# Access Compliance Report

## Public Rights-of-Way

### (Curb Ramps)

Intersection ID: 15145	Main Street: DIANA_DR	Cross Street: IVERSON_WY	Location: S
ADA ID: 2462B334FC23	Ramp Type: Directional1	Initial Pass/Fail: Fail	Overall Compliance: No
Severity Score: 1.25			
Codes/Mitigation Info/Possible Solution		Field Measurements/Component Compliance

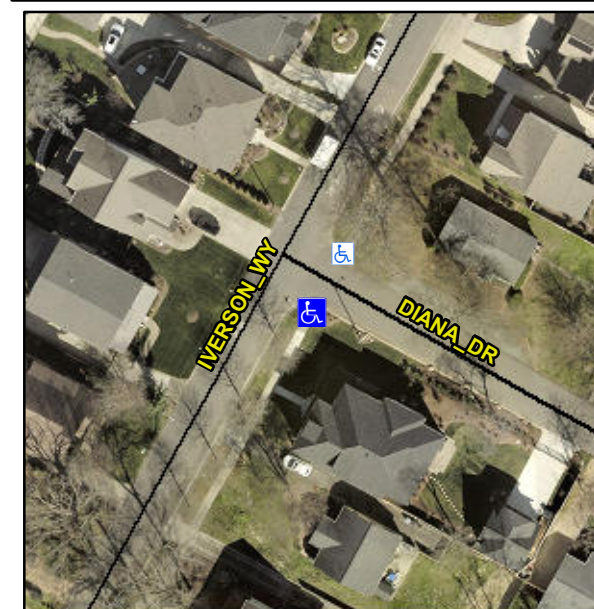
**Remove & Replace Entire Ramp.**

**R304.5.3**
